**SUBJECT:** **Safety Recall 19S54 – Supplement #1**

Certain 2006-2010 Model Year Fusion/Milan/MKZ/Zephyr Vehicles Equipped with Anti-Lock Brake Systems  
 DOT 3 Brake Fluid and Anti-Lock Brake System Function

**New! REASON FOR THIS SUPPLEMENT**

FIGURE 15

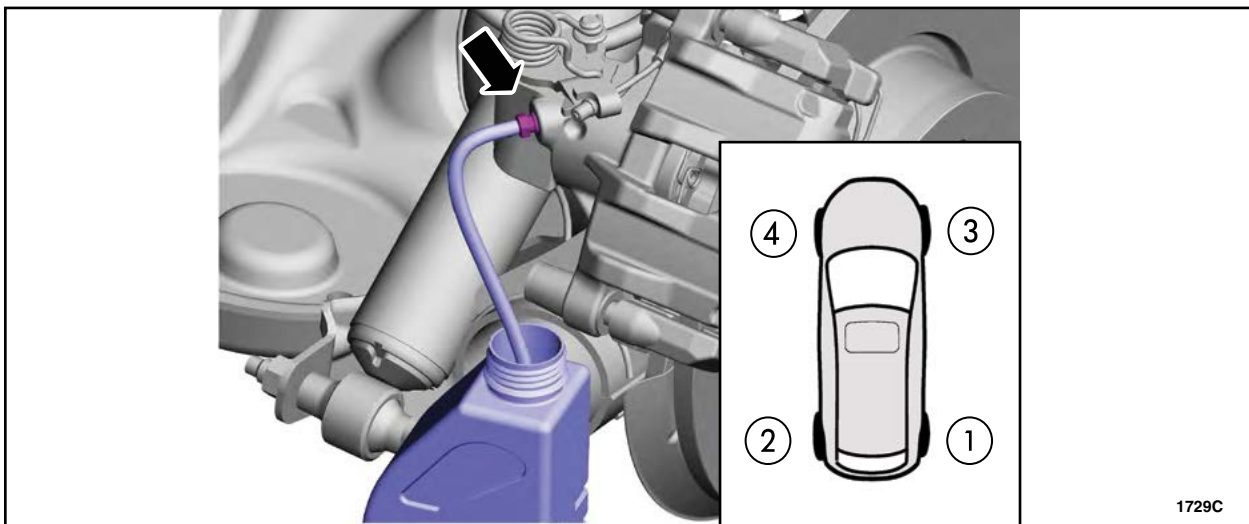
6. Loosen all four caliper bleeder screws in the order indicated. See Figure 15. Allow approximately 10 fl oz (295.7 mL) to drain from each bleeder screw, **one wheel at a time**.

- Once 10 fl oz (295.7 mL) of brake fluid has drained from each of the four caliper bleeder screws, tighten to 8 Nm (71 lb in).

**NOTE:** If the brake fluid is slow to drain from any of the four caliper bleeder screws, press the brake pedal once or twice to increase the flow while the pressure bleeder is still running, and then as required to drain the 10 fl oz (295.7mL).

FIGURE 24

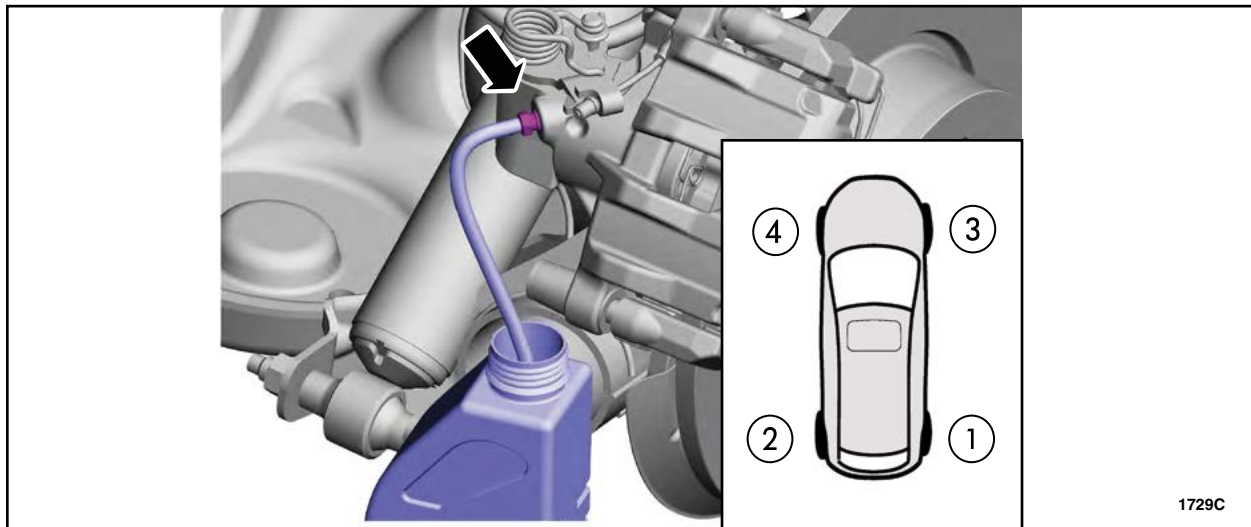
**NEW !** 6. Loosen all four caliper bleeder screws in the order indicated. See Figure 24. Allow approximately 10 fl oz (295.7 mL) to drain from each bleeder screw **one wheel at a time**.

- Once 10 fl oz (295.7 mL) of brake fluid has drained from each of the four caliper bleeder screws, tighten to 8 Nm (71 lb in).

**NOTE:** If the brake fluid is slow to drain from any of the four caliper bleeder screws, press the brake pedal once or twice to increase the flow while the pressure bleeder is still running, and then as required to drain the 10 fl oz (295.7mL).
